**MEETING AGENDA OF THE
PLANNING COMMISSION OF THE TOWN OF FRISCO
FRISCO TOWN HALL
1 MAIN STREET
FRISCO, COLORADO 80443
JULY 16, 2026
5:00 PM**

AGENDA ITEM: Planning File No. MAJ-25-0002: A final site plan review of a proposed mixed-use development consisting of six (6) residential units and two (2) commercial units

SIXTH DEGREE TOWNHOMES
121 EAST MAIN STREET, FRISCO COLORADO 80443
(LOTS 1 & 2, BLOCK 2, KING SOLOMON ADDITION AND THE WEST 1/2 OF VACATED 2ND AVENUE)

MARCIN ENGINEERING LLC 101 EAGLE ROAD, #5 AVON, COLORADO 970-748-0274	
SITE & UTILITY PLAN SIXTH DEGREE TOWNHOMES LOTS 1 AND 2, BLOCK 2, KING SOLOMON ADDITION 121 MAIN STREET TOWN OF FRISCO, COLORADO	
NO.	DATE
REVISIONS	
BY	
DATE	
NO.	
JOB: 21112 DATE: 06/25/2026 SCALE: 1" = 10'	
SHEET C-1

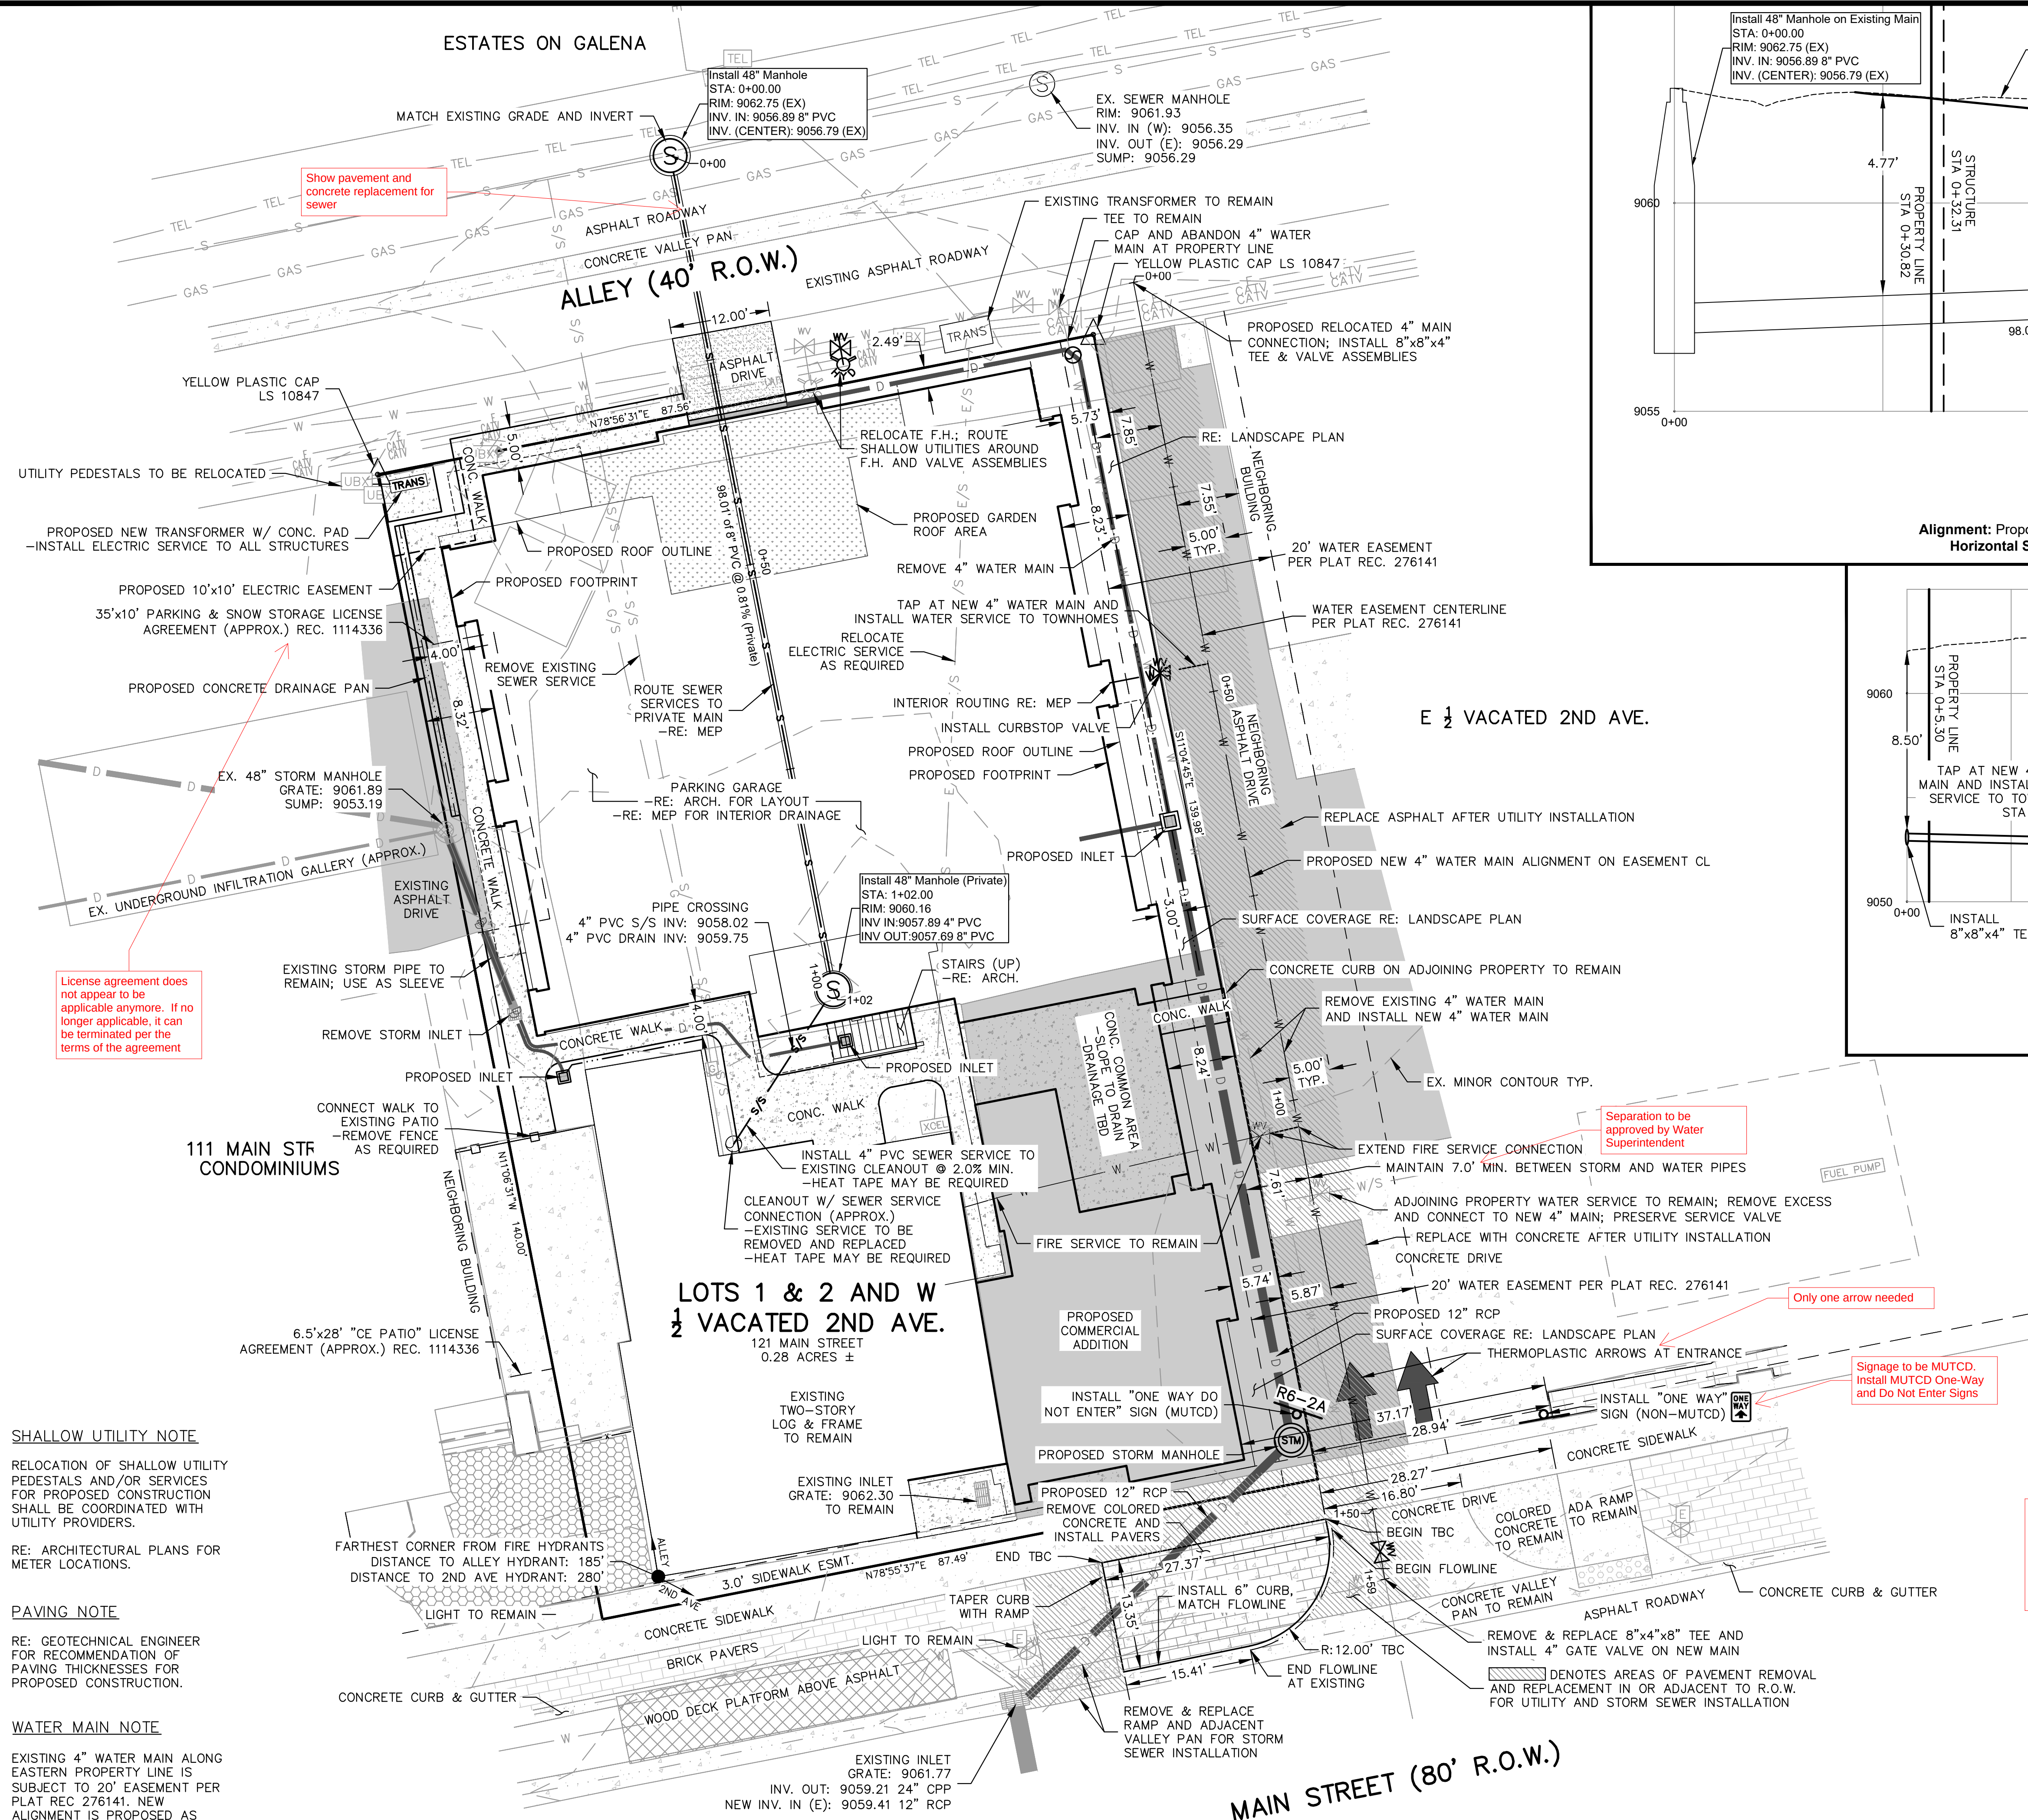
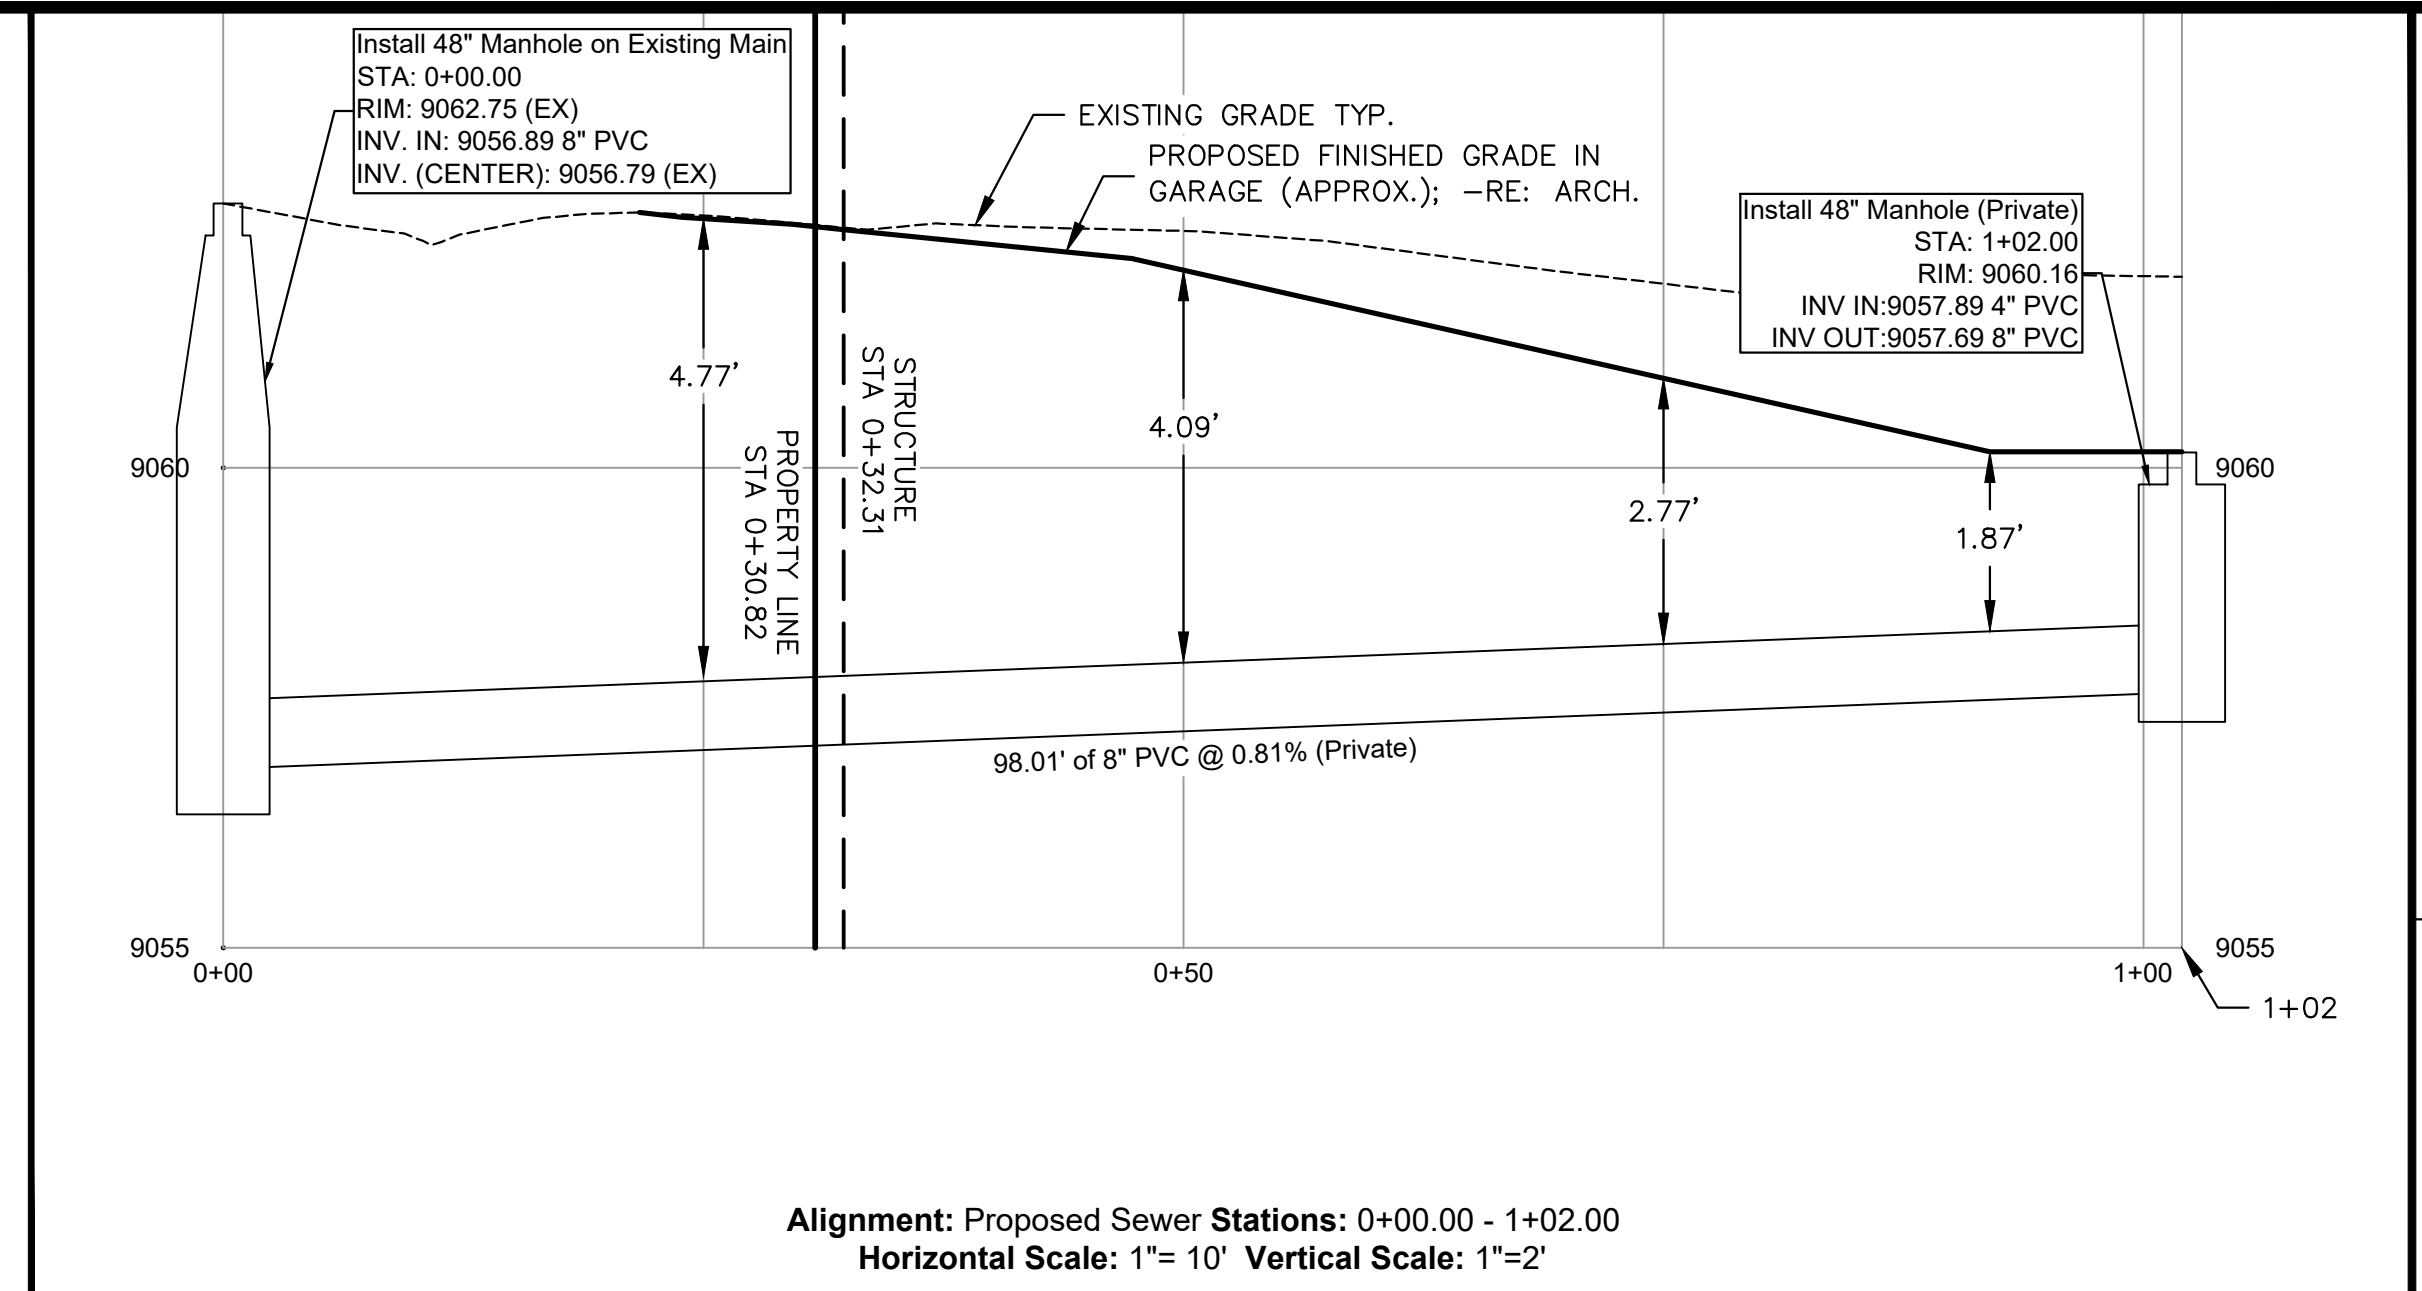
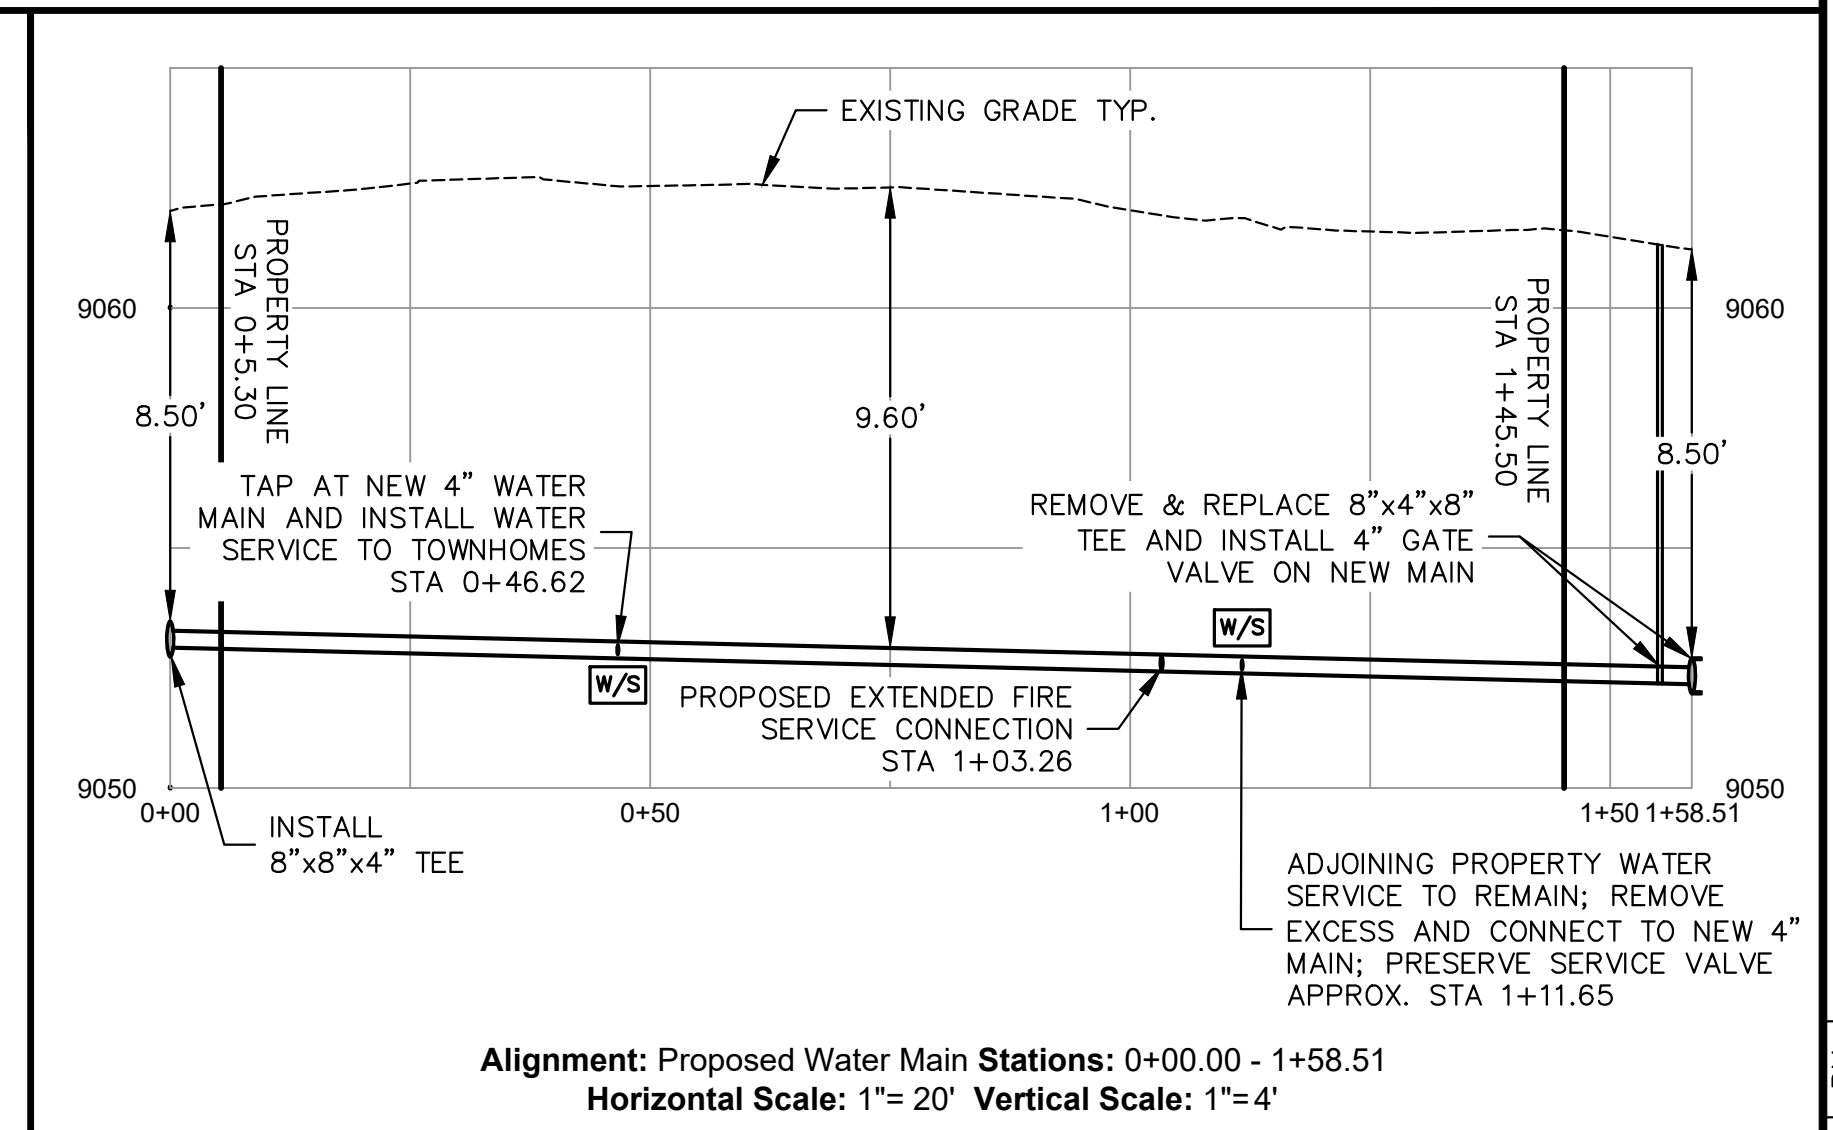
- The Loaf 'N Jug access changes do not meet code, would misalign with the 2nd Ave intersection, and vehicle turning movements do not work for two-way traffic per attached vehicle tracking. One-way and do not enter signs required to modify access to one-way inbound traffic
- Sheet SP-1.2 states that existing shed to remain. The shed will require removal to install water line. The existing water easement provides access to remove and relocate in order to maintain and replace water infrastructure
